**General
Service
Bulletin**

CVHE-SB-24

Subject: CVHE Vane-Actuator Motor Limit-Switch Gear Replacement Kit

Figure 1
Vane-Actuator Limit Switch Assembly
(Conduit Box Cover Removed)

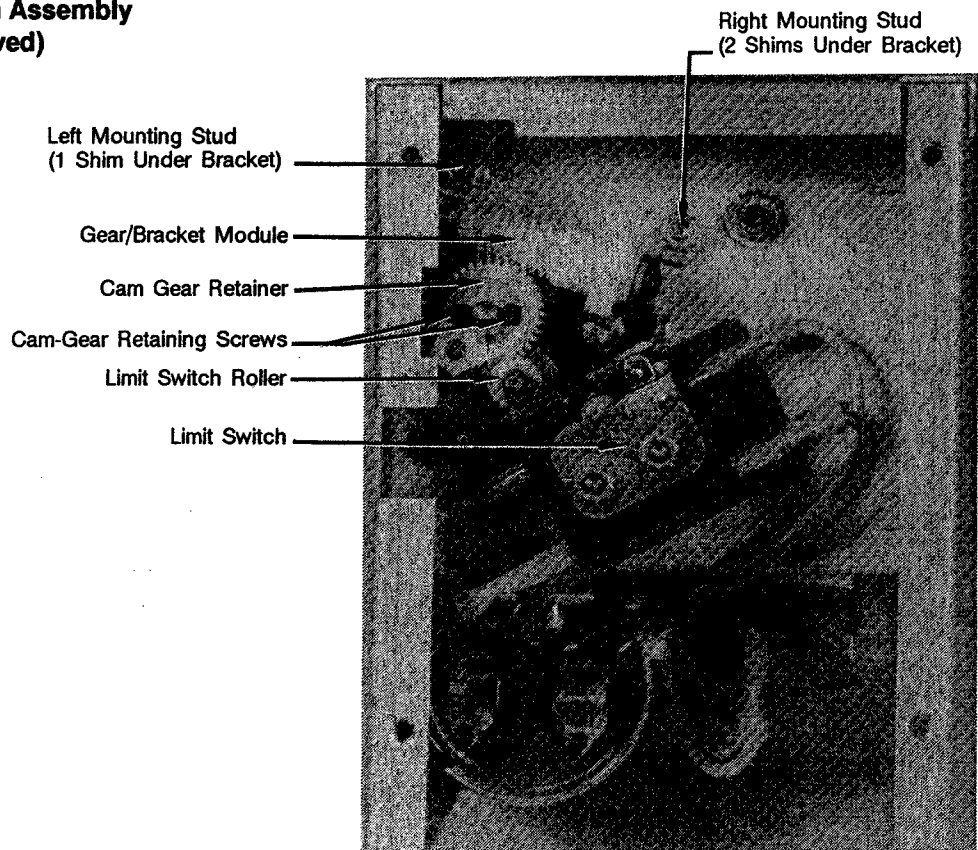
A kit is now available for replacing the plastic worm-gear assembly in the CVHE vane-actuator motor limit switch. This kit is part number **GER-0315**. The vane-actuator motor has failed on several occasions due to stripped gears in the limit switch.

2. Remove and set aside the eight retaining screws from the actuator conduit-box cover. Remove the conduit box cover, exposing the limit-switch gear assembly. See Figure 1.

It is not usually necessary to replace the cam gears. If they require replacement, however, remove and discard the cam retaining screws, the cam retainer, and the old cam gears. Install the new cam gears and retainer using the new screws provided in the kit. Cams should be installed on left side of the cam roller as shown in Figure 1. Start but do not fully tighten the cam-retaining screws at this time.

6. Place one new shim (Figure 2) on the left gear/bracket mounting stud (Figure 1) and place two new shims over the right gear/bracket mounting stud (Figure 1).

7. Position the new gear/bracket module (provided in the kit) over the mounting studs and install the new mounting nuts (provided in the kit) on the studs. Do not tighten the nuts fully at this time. Adjust position of gear/bracket module to engage both gear sets; then tighten the mounting nuts.

8. Then, check both gear sets for backlash. Gears should rotate slightly, but not excessively. Movement should be restricted to .005 to .010 inches.

Figure 2
Vane-Actuator Motor Limit Switch Gear
Replacement Kit

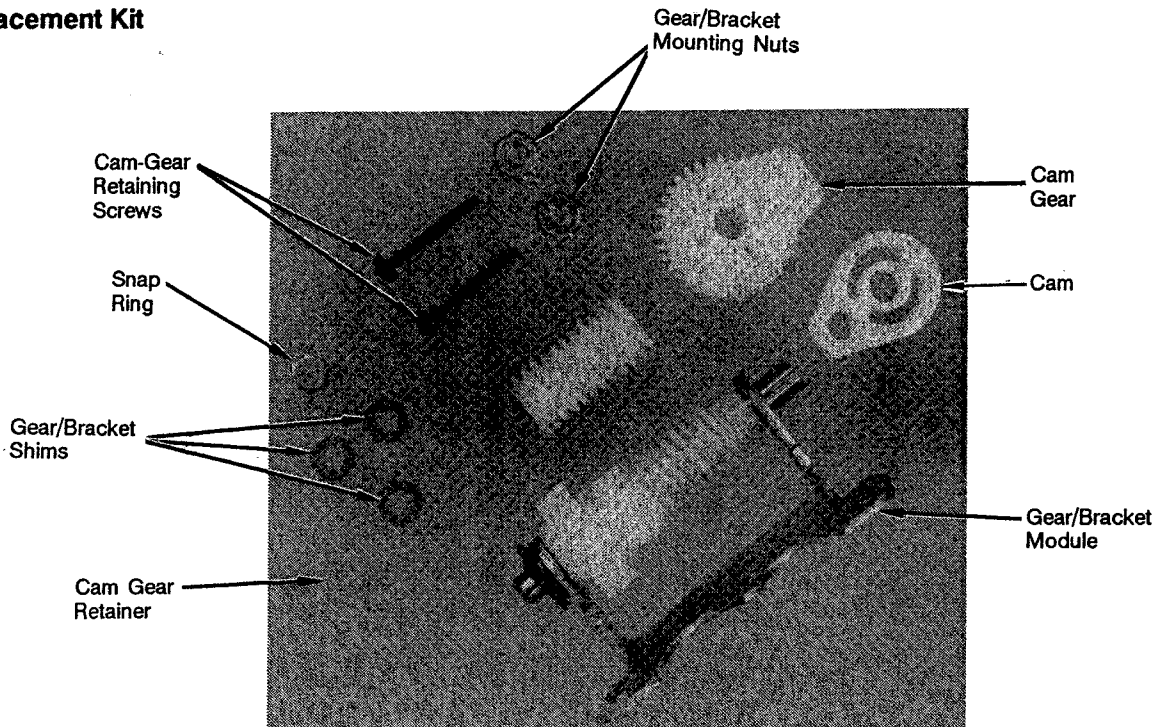
5. Mount the new worm gear (provided in the kit) on the motor shaft with hex-end toward actuator motor. Kit components are shown in Figure 2. The snap-ring groove should be exposed. Install the new snap ring (provided in the kit) in the groove. Check the worm gear to be sure it is secure on the motor shaft.
